Subject: DA 2022/2213 – 24 Alan Avenue SEAFORTH - Letter of Objection

DA 2022/2213 – 24 Alan Avenue SEAFORTH NSW 2092

WRITTEN SUBMISSION: LETTER OF OBJECTION

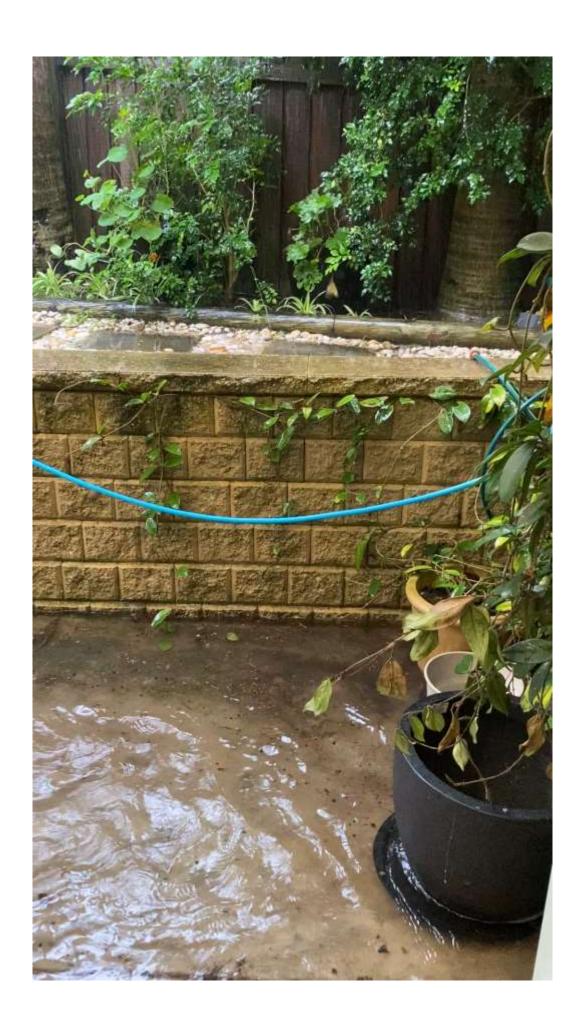
The backyard of our property at 98A Seaforth Crescent is below the level of both 22 and 24 Alan Avenue. Despite a network of agricultural drains on our property linking to a stormwater pipe, the runoff from Alan Avenue has already exceeded critical levels for a number or years. Underneath our house is damp and muddy with flowing water after rain.

We already receive considerable runoff from 24 Alan Avenue in the rear right hand corner of our yard as well as from 22 Alan Avenue (about which Council received correspondence from us in 2016).
